RE: Submission / Observation on Application Reference -PAX12.324290 (ACP-324290-26)

Proposed Lissinagroagh Wind Farm — application by FuturEnergy Lissinagroagh Designated Activity Company for a Strategic Infrastructure Development under section 37E of the Planning and Development Act 2000 (as amended), for a 10-year permission for 14 no. wind turbines (blade tip height 180–185 m) and all associated infrastructure, in the townlands of Boleyboy, Cashelaveela, Cherrybrook, Killea, Coolodonnell, Faughary, Lissinagroagh, Lisdarush, Lugasnaghta, Raheelin, Shasmore, Tawnyfeacle and Tullyskeherny, Co. Leitrim (approximately 3 km northeast of Manorbhamilton).

Case type- Private Development - REDIII Application

Figure 3- extract from Tobin Drawing 10955-026-GCR-TDR-TOB-D01- indicating WFD water bodies

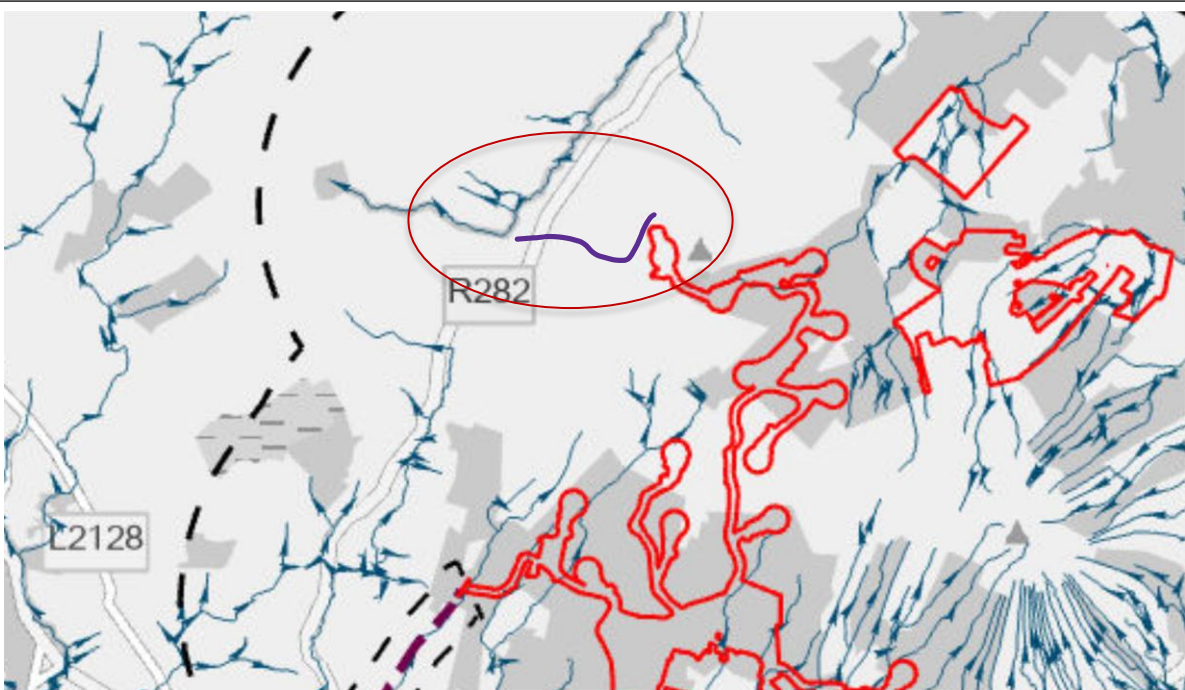
Specifically, at least one clearly defined watercourse that exists on these lands, and is known to us locally, has not been identified, mapped or assessed in the application documents. The watercourse in question passes beneath the R282 regional road and is physically evidenced by a road bridge crossing at approximately latitude 54.350375, longitude -8.145072 (WGS84).

It can be traced from the vicinity of the proposed turbine location T3, down the western flank of Saddle Hill, to the Ballagh River. The Ballagh River is a principal tributary of Lough Melvin, which is a European site (Special Area of Conservation). This watercourse is, in our direct experience of these lands, the receiving conduit for surface water runoff generated on the western side of Saddle Hill — including the ground on which T3 and its associated access and hardstanding works are proposed.

The significance of this omission is not merely cartographic. The applicant's own conclusions of “*no significant effect*” on water quality and on the Lough Melvin SAC are built upon the pathways that the applicant chose to map. A pollutant pathway that has not been identified is, by definition, a pathway that has not been assessed and for which no located mitigation has been designed. Where that unassessed pathway leads directly to an already-impaired European site, the reliability of the entire assessment is called into question.

Figure 2-2 of Appendix 8-1 (“Regional natural surface water drainage pattern in the environs of the proposed project”) and the related surface water mapping purport to depict the drainage network in the vicinity of the proposed development. The watercourse we identify — crossing the R282 at the bridge structure referenced above — does not appear on this mapping, nor is it referenced in the connectivity narrative at Sections 2.1.1 and 2.1.1.1 of Appendix 8-1.

- Require the applicant to revise the surface water and connectivity assessment, the drainage design and the mitigation strategy (CEMP/SWMP) to identify, characterise and specifically mitigate the construction-phase sediment and pollution risk along the pathway from T3 and the western flank of Saddle Hill to the Ballagh River and Lough Melvin SAC;

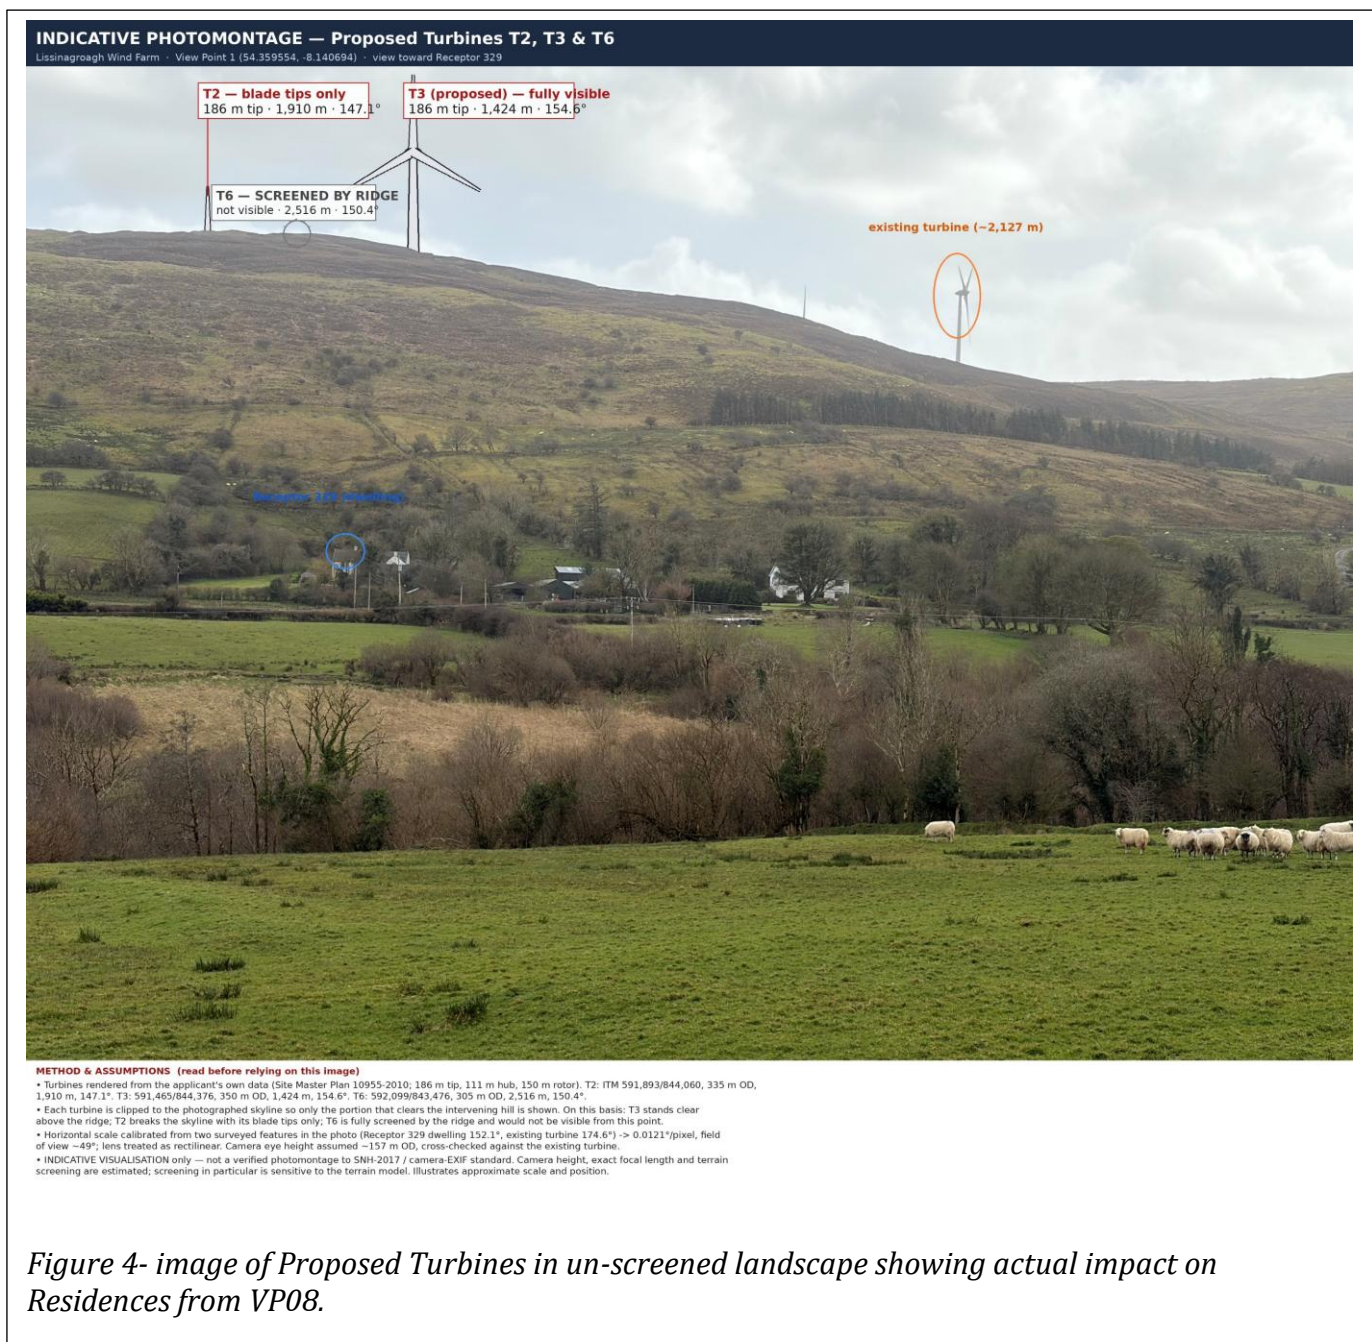
We are also concerned that the photomontages understate the true visual impact, being taken from a limited set of locations and, in places, when trees are in full summer foliage, so that screening is overstated relative to winter conditions. We ask the Commission to view the montages critically and, where possible, to consider the winter, leaf-off situation. In relation to our own home specifically, we raise a further and more particular objection to the adequacy of the photomontage prepared for Viewpoint VP8 at Section 3.4 above.

Figure 4 above, whilst not a fully verifiable view, has been professionally constructed using GPS coordinates and known elevations to illustrate accurately the impact of T3 in particular which is clearly out of scale and context with the rest of the development having a significant impact on the skyline being positioned almost at the crest of Saddle Hill. The impact of T2 & T6 is less as they are partially screened by the ridge line. We would again urge ACP to insist that the applicant represent their verified view with photography taken during the winter months and focused on parts of the landscape where the impacts can be fully appreciated by the residents living in that locality.

INDICATIVE PHOTOMONTAGE — Proposed Turbines T2, T3 & T6

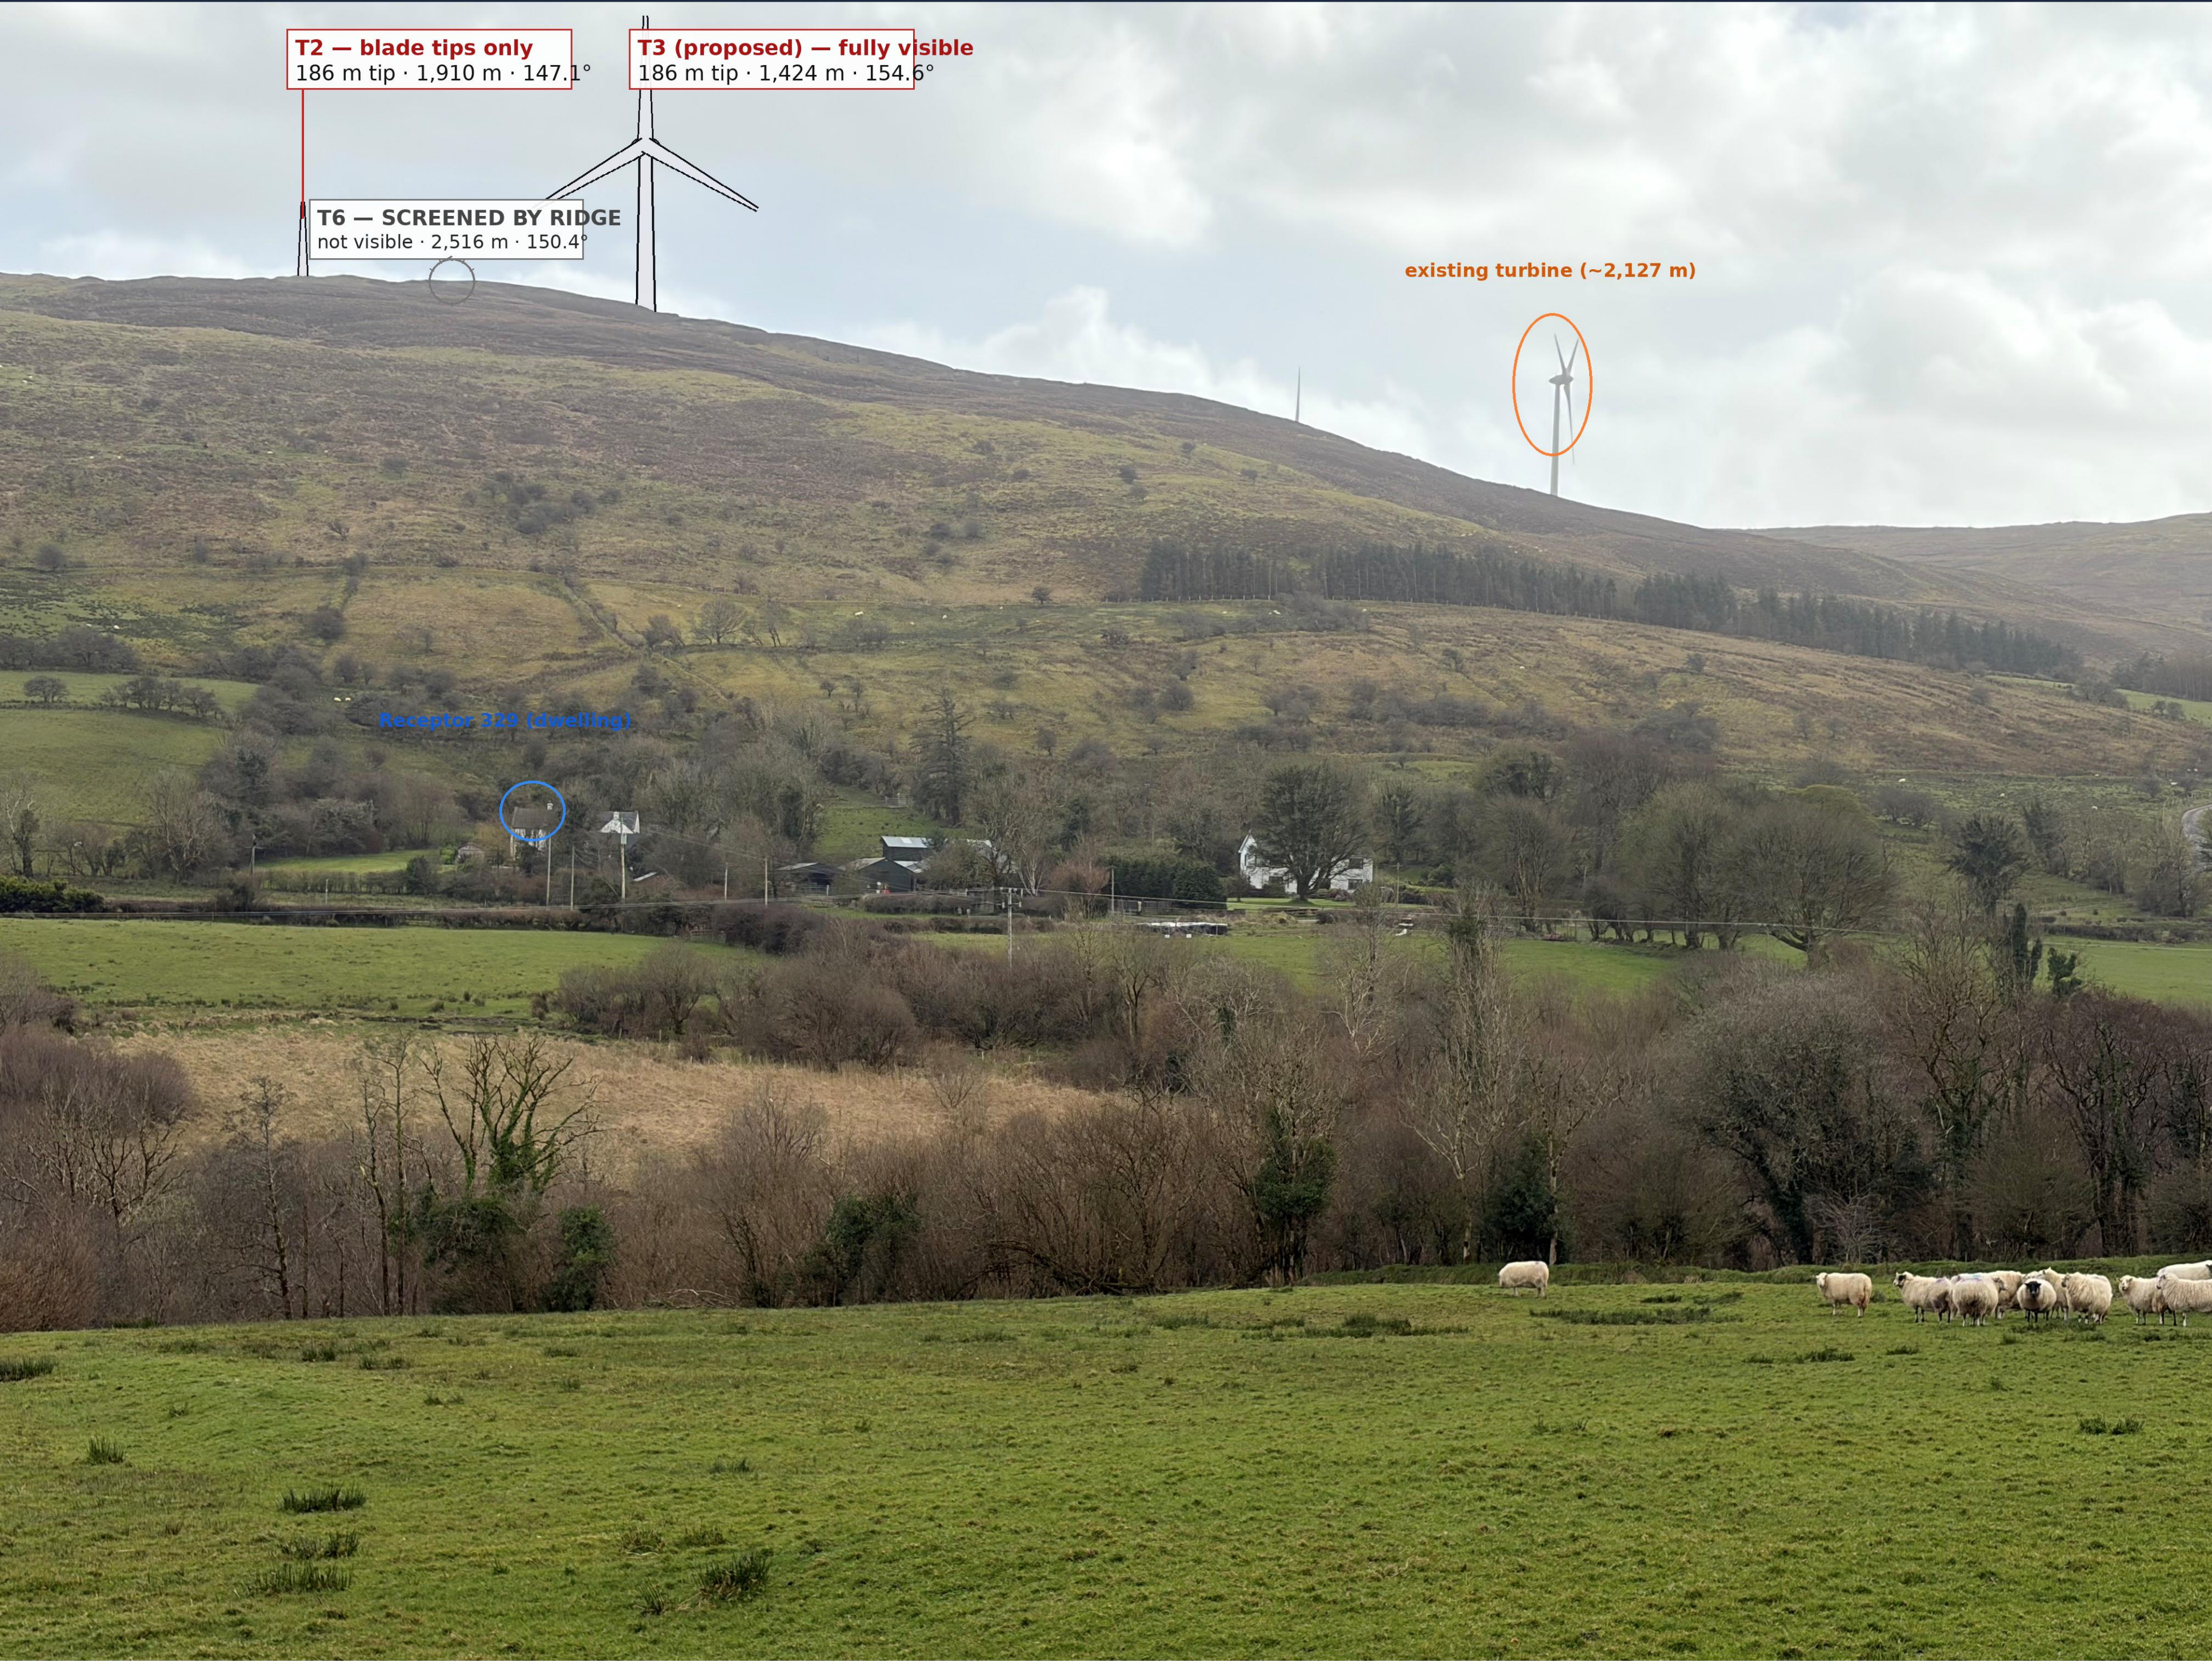
- **Visual dominance and an unreliable visual assessment.** T3 is the turbine nearest our home and the only proposed turbine towards which the single representative viewpoint for this locality (VP8) is oriented. As set out at Sections 3.4 and 3.9, that viewpoint is substantially screened by incidental roadside vegetation, so that neither our home, nor the cluster of dwellings sharing this outlook, nor the true, unobstructed scale of T3 on the ridgeline, is conveyed by the photomontage relied upon; and the applicant's own VP8 record sheets are internally inconsistent as to whether T3 is even the nearest visible turbine. The visual impact of T3 on this cluster of homes has therefore not been reliably assessed.

Photo Montage of T3 clearly illustrates impact on our Residential Amenity.
